VIBRATION NOISE IN CALGARY FRIDGES (RF330, RF400)**DESCRIPTION:**

Vibration noise from the compressor area and the lower part of the back condenser.

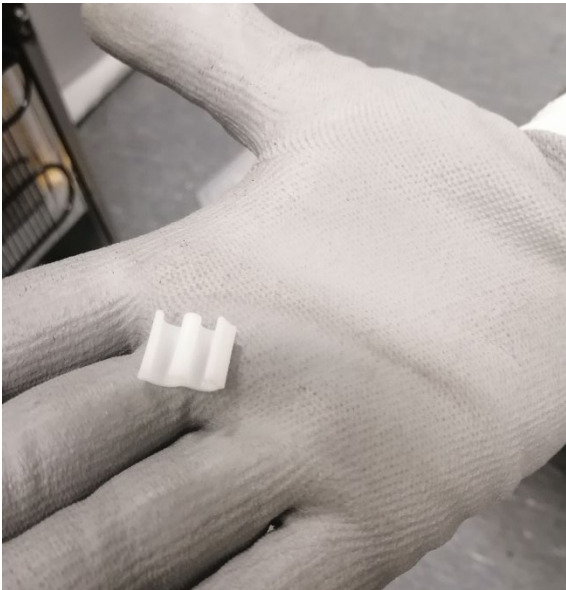
4. Stick adhesive tape under the supplementary water tray directly on the support plate.

- Fix the supplementary water tray using adhesive tape
- Fit three-way rubber spacers to the middle part of the spiral tube
- Fit a spacer to the vertical tube of the condenser

5. Pull the tray back to the original position and push it to the adhesive sponge.
6. Fix the support screws.
